RE: ARRANGEMENT OF TACTILE WALKING SURFACE INDICATORS (TWSI)

**CURB RAMPS
TYPE M - MIDBLOCK
REVISED FOR CLARIFICATION NOV 2022**

Scale:	NTS
Created:	OCT 2019
Rev Date:	MAY 2020
Dwg No:	CS-16

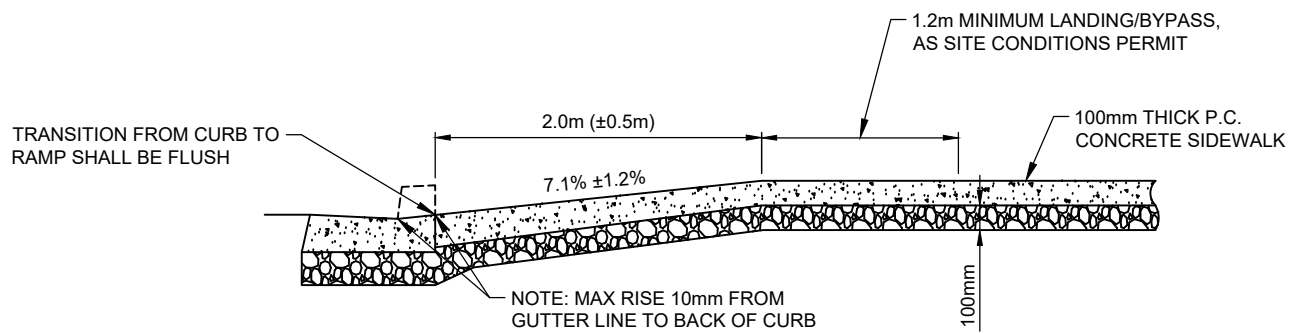
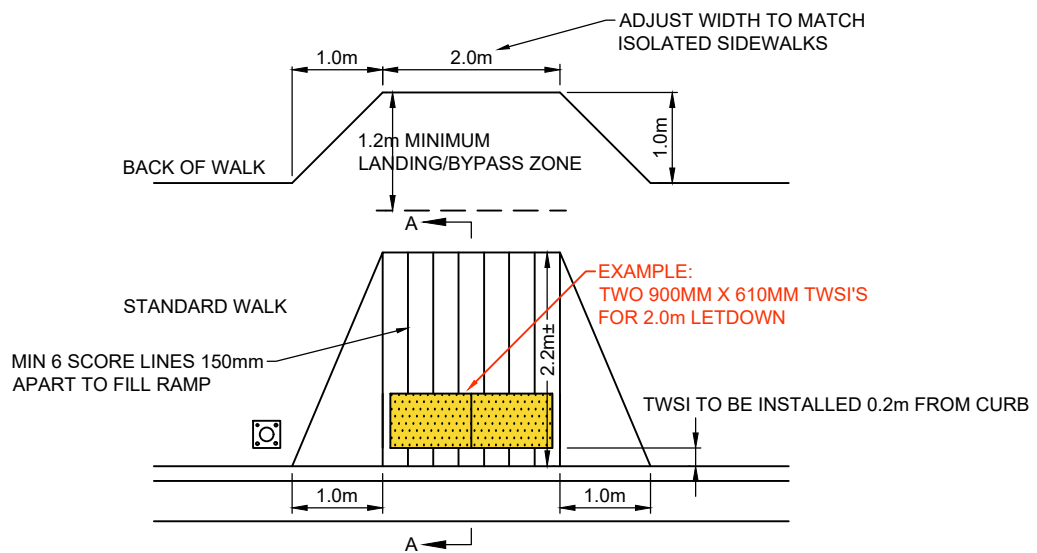
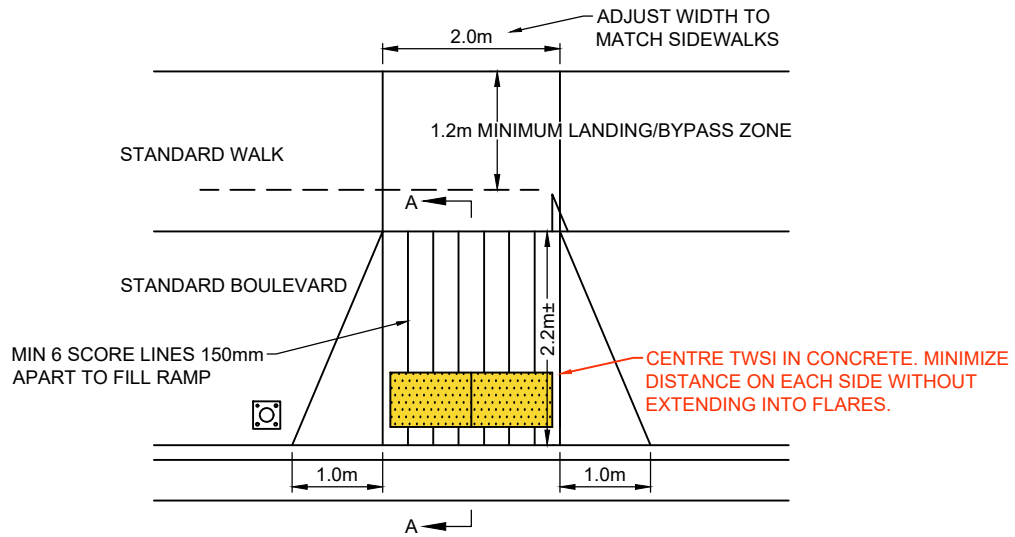
Section 8.10.2(b) of the MOESS states that the TWSI is to “measure across the entire width of a hazard...” however, with the minimum width of 0.61 the cast in place TWSI’s come in standard lengths of 0.9m, 1.2m and 1.5m lengths.

The expectation is that the maximum amount of the hazard be covered by a combination of these lengths without physical modification (cutting). For example, a 2.0m wide letdown should have two 0.9m wide TWSI’s centered on the score lines. Please see attached mark up of CS-16 for reference.

Going forward, the Design Engineer is to provide TWSI dimensions and to show the score lines on the project drawing set. Effective January 1st 2023, any TWSI installations that are undersized and do not conform to the clarification outlined above will be considered deficient and will require removal and reinstatement.
